EIA Doel 4 - Tihange 3

Technical opinion on the EIA report

Answers to questions raised in the report by Umweltbundesamt GmbH, Austria

Evaluation of Belgium answer to

Question 27: chart(s) depicting radiological impact prepared for all the concerned geographical area

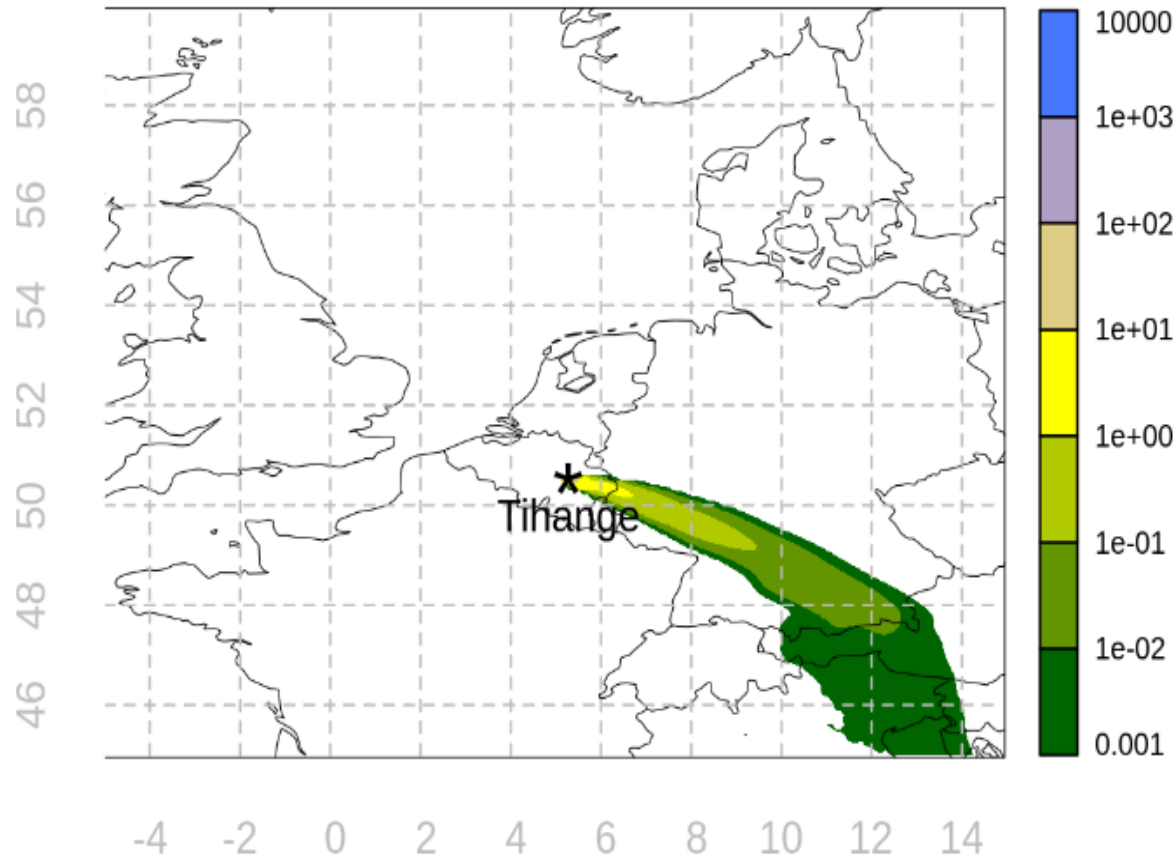
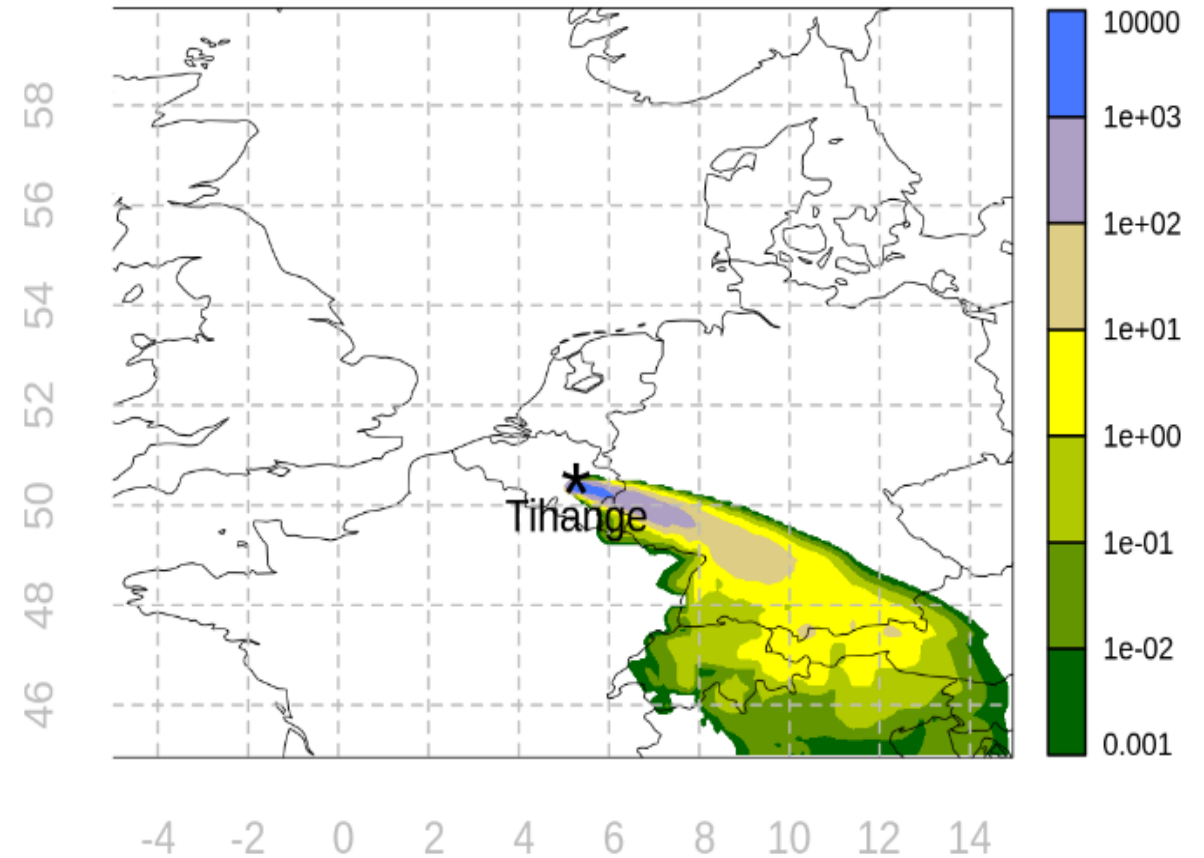
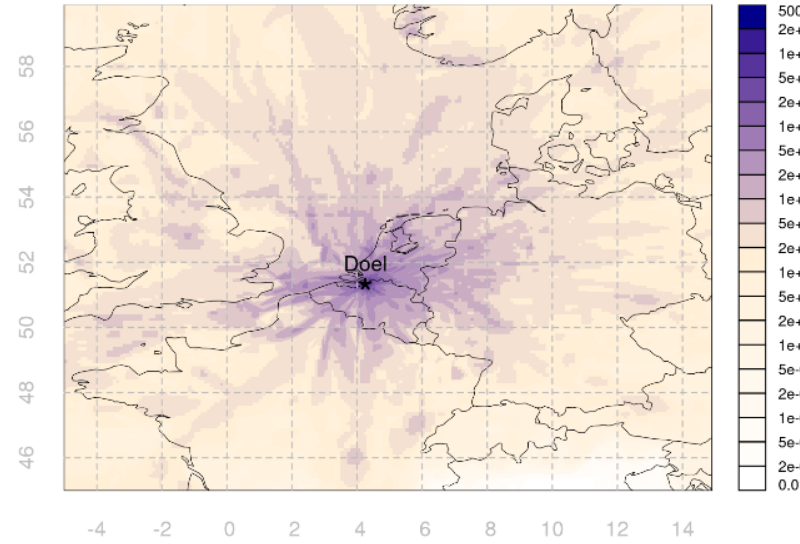
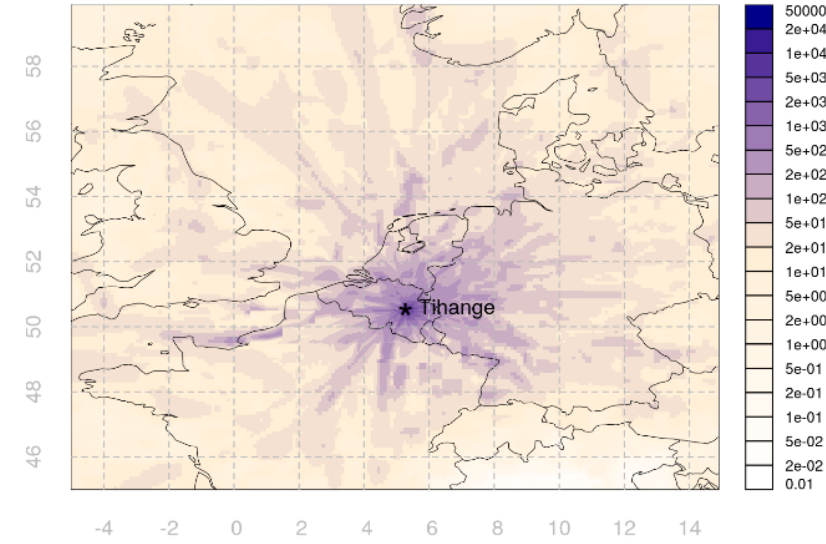
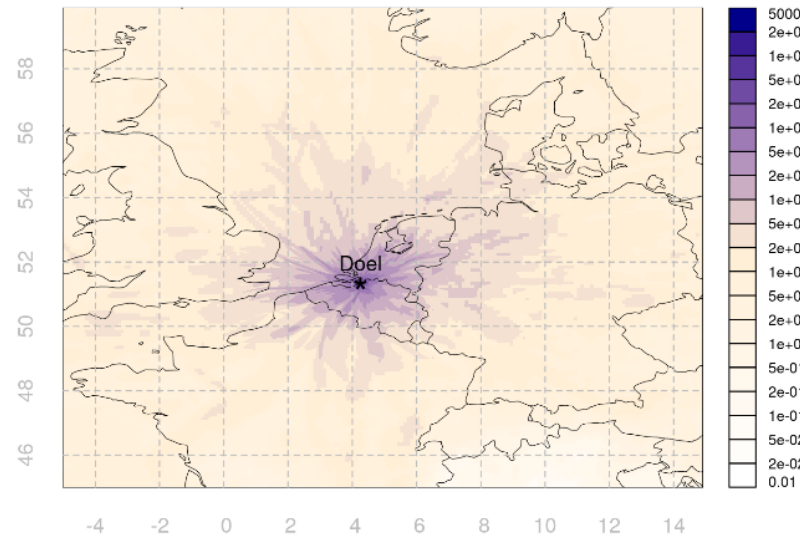
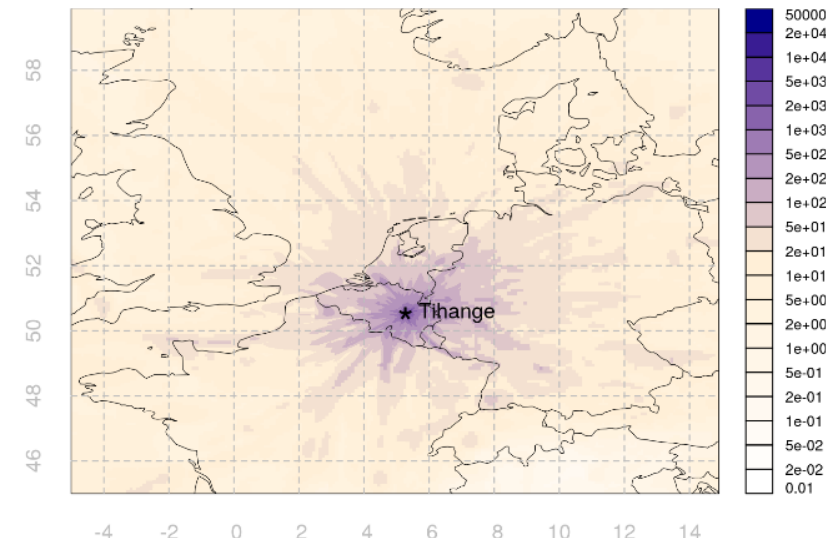
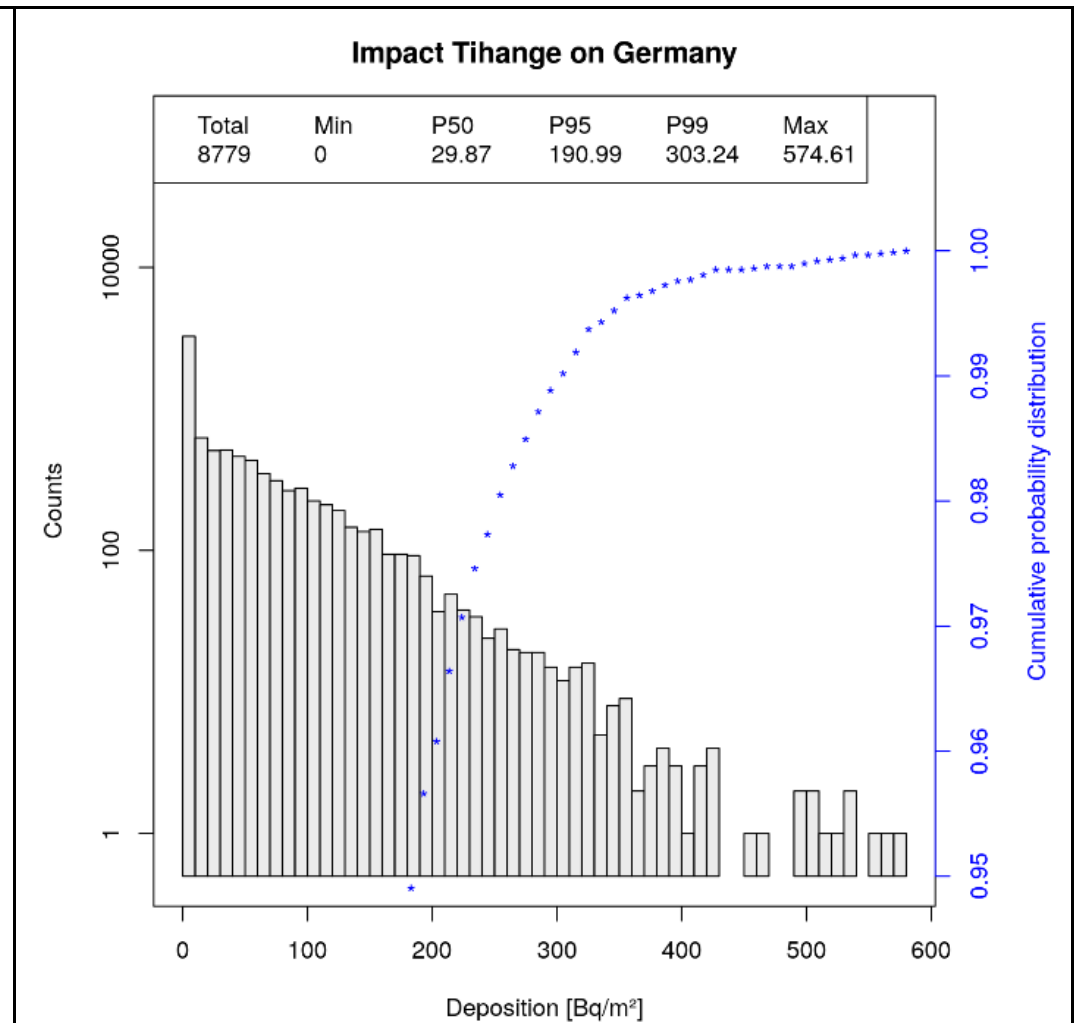
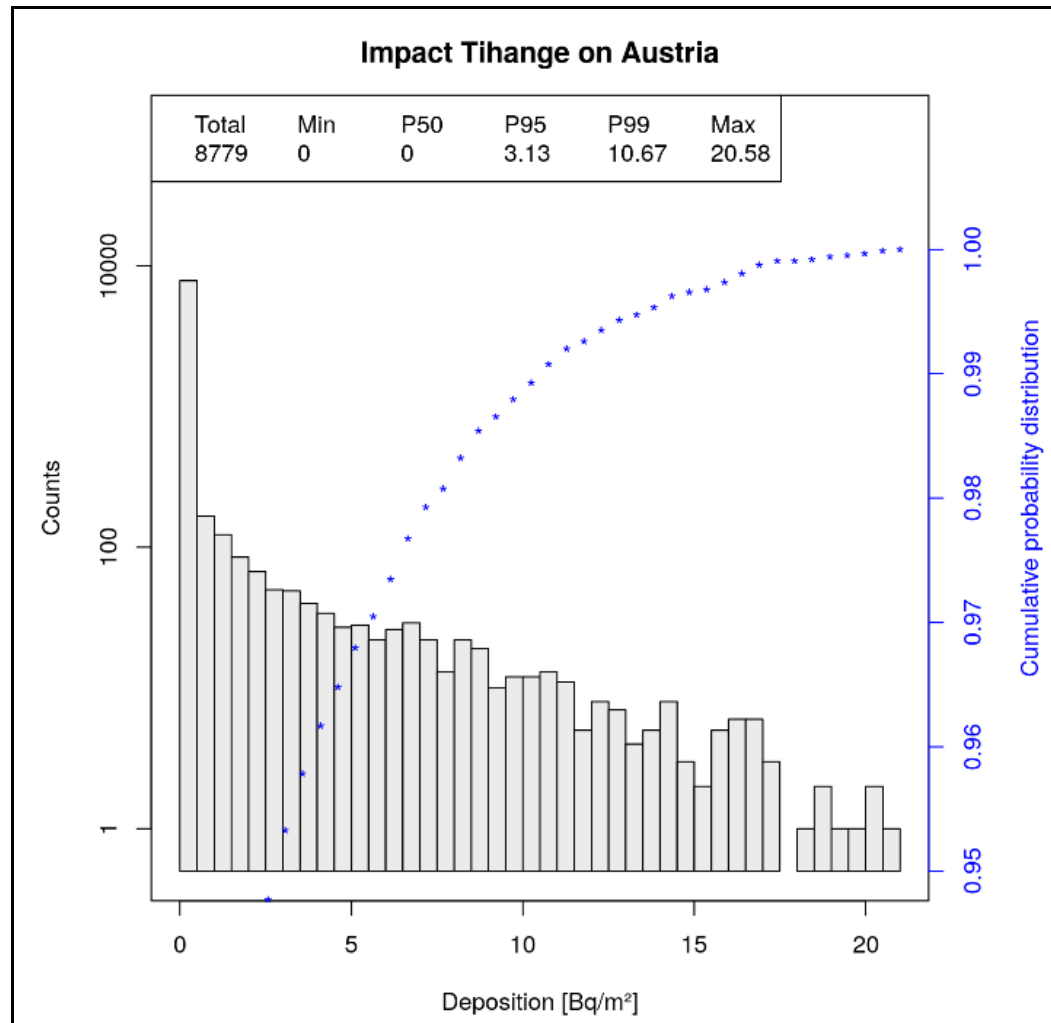
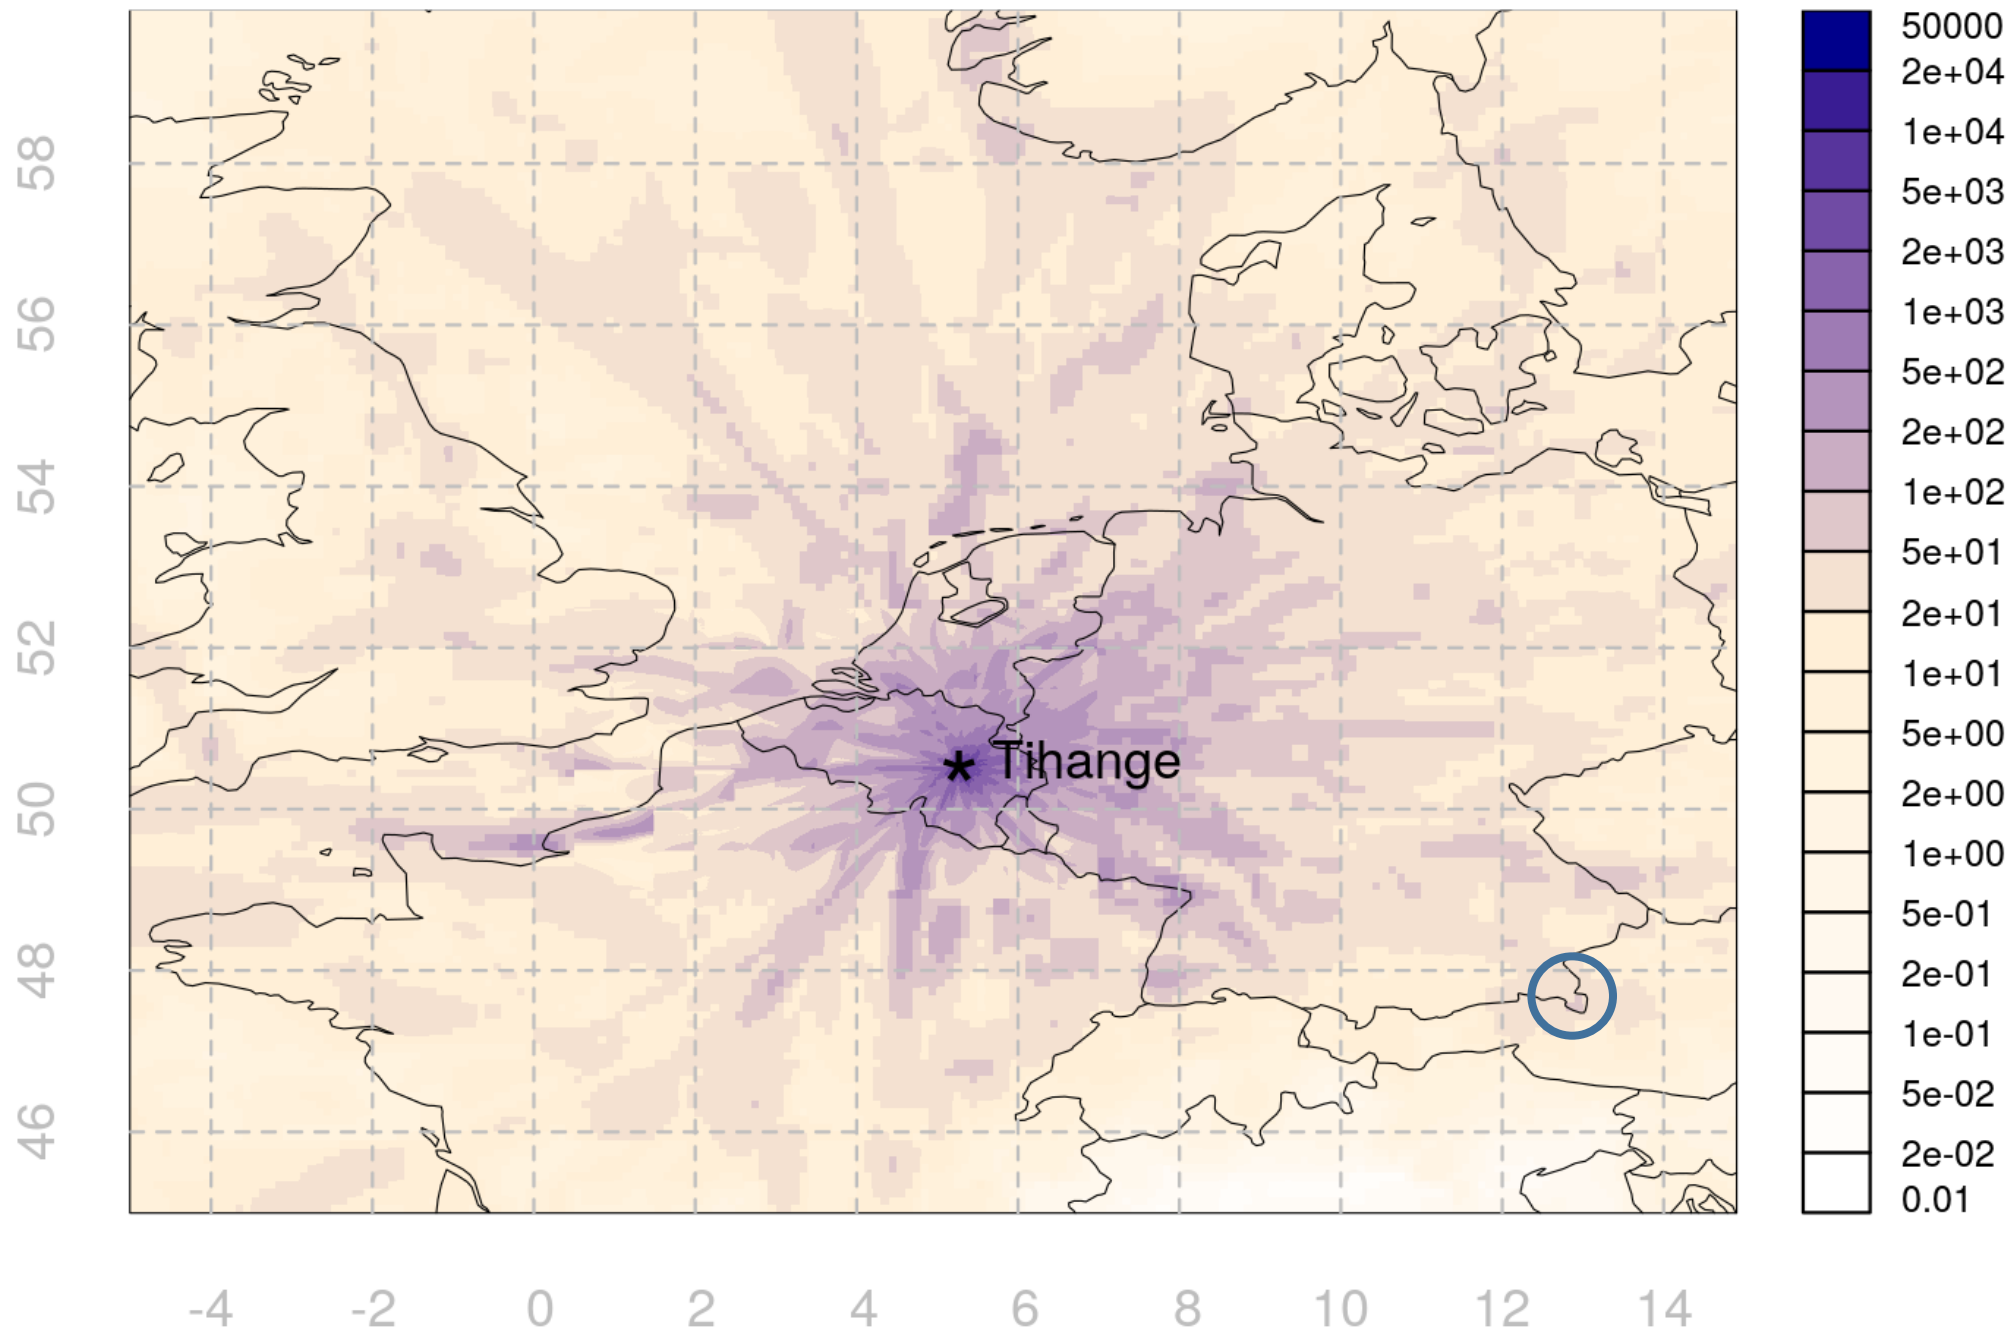
Question/discussion During bilateral in-person consultations we would like to obtain further details, in particular access to the chart(s) depicting radiological impact that are indicated to have been prepared for all the geographical area that is indicated in Figure 19 of the EIA.

Question/discussion During bilateral in-person consultations we would like to obtain further details on the profile of the deposition for all areas as depicted in Figure 19, and in particular for the pre-Alpine and Alpine areas in Austria.

- Results of one of the > 8000 simulations for assessing the impact on Austria for a release with a duration of 6-hours of aerosols ($Cs_{137}+Cs_{134}$) from Tihange 3. Left the time integrated concentration (TIC) and right the deposition.
- In this case the meteorological conditions are such that Austria is reached, however in >50% of the time/simulations, meteorological conditions are such that Austria is not reached (see further).

Statistical distribution of the >8000 simulations of maximum deposition value in Austria from a 1 TBq release of aerosols from Tihange 3. For comparison same graph for Germany.

The left axis and black bars show the number of cases (simulations) as a function of the deposition. More than half of the simulations (meteo conditions) result in no deposition in Austria.

Maximal I₁₃₁ and Cs₁₃₇+Cs₁₃₄ depositions is Austria over all accident scenarios studied in the EIA and over all meteorological conditions studied (>8000). A comparison with Germany is added.

Indication
(blue circle)
of maximum in
Austria for
deposition after
a 1 TBq aerosol
release from
Tihange
